SUBJECT: UPPER HEAD INJECTION SYSTEM REMOVAL, BORON INJECTION TANK
DEACTIVATION, AND CLOSEOUT OF TEMPORARY 50.46(a)(1) EXEMPTION
(TAC 75747, 75749, 76677) (TS 89-25 and 89-26) -
SEQUOYAH NUCLEAR PLANT, UNIT 1

AMENDMENT NO. 140 FOR SEQUOYAH UNIT NO. 1 - DOCKET NO. 50-327
DATED: May 11, 1990

TENNESSEE VALLEY AUTHORITY
DOCKET NO. 50-327
SEQUOYAH NUCLEAR PLANT, UNIT 1
AMENDMENT TO FACILITY OPERATING LICENSE

Amendment No. 140
License No. DPR-77

Figure 3.2-2

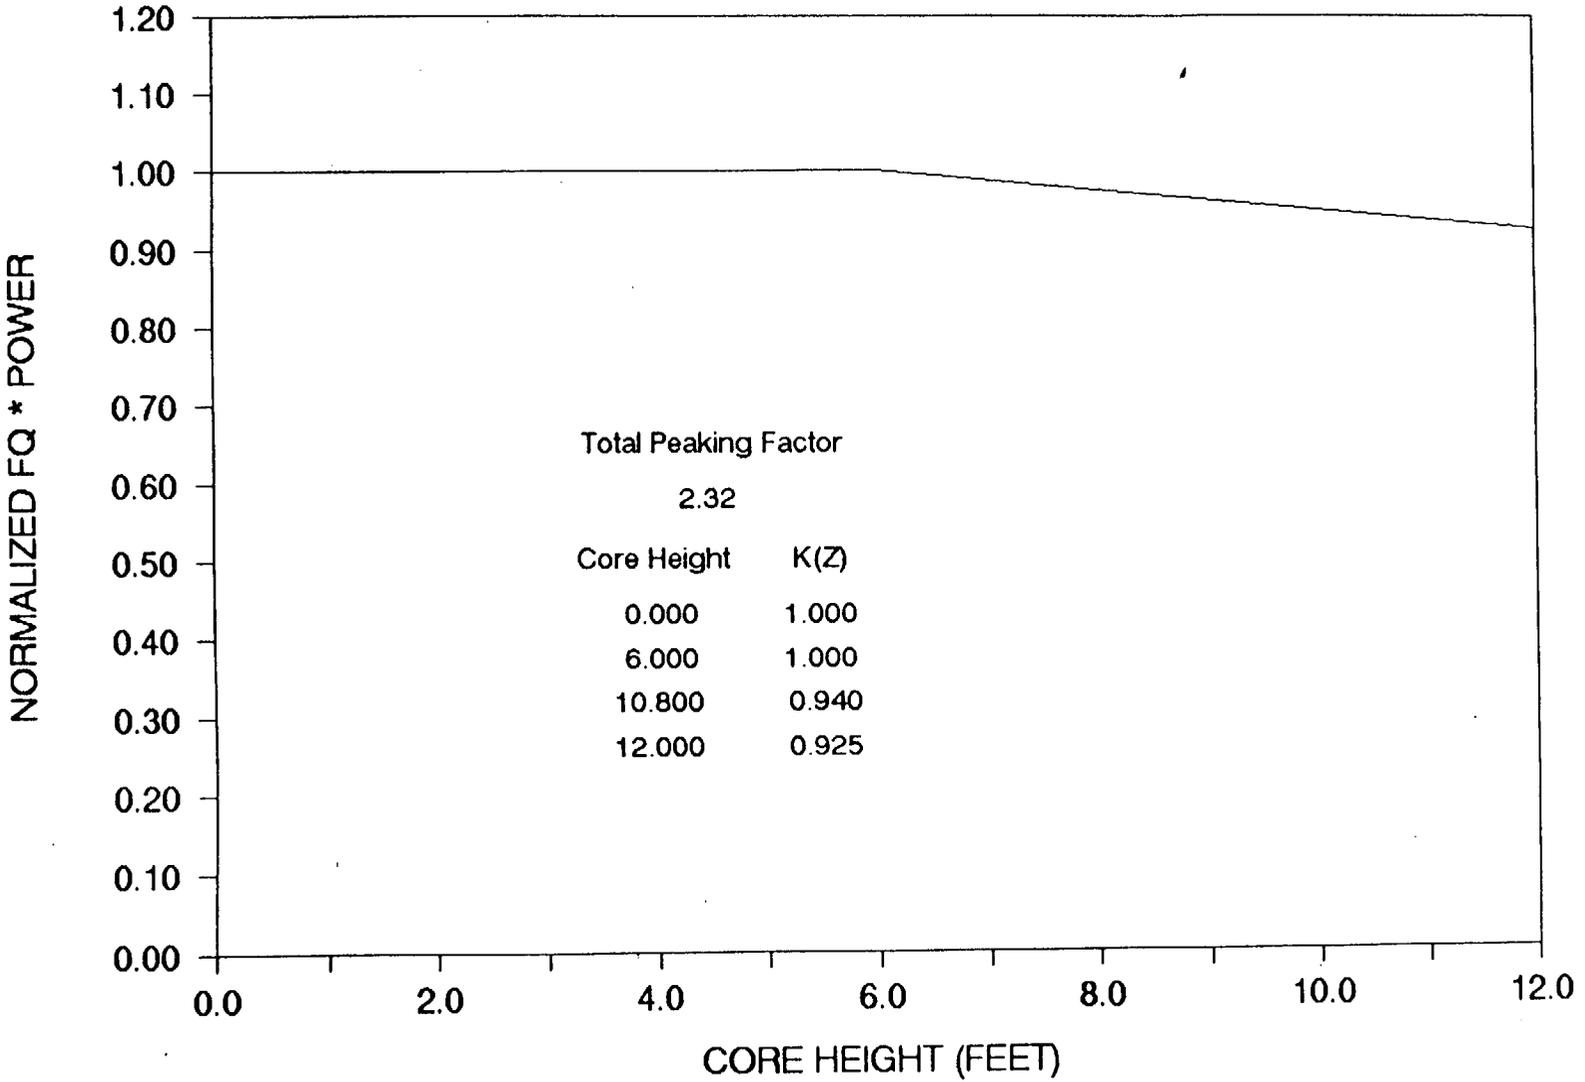
The proposed change would revise the total peaking factor from 2.15 to 2.32 and also replace Figure 3.2-2, the $K(z)$, i.e., the normalized $F_Q(Z)$ curve.

3.2.2 $F_Q(Z)$ shall be limited by the following relationships:

$$F_Q(Z) \leq \frac{[2.32]}{P} [K(Z)] \text{ for } P > 0.5$$

$$F_Q(Z) \leq \frac{[2.32]}{0.5} [K(Z)] \text{ for } P \leq 0.5$$

and $K(Z)$ is the function obtained from Figure 3.2-2 for a given core height location.
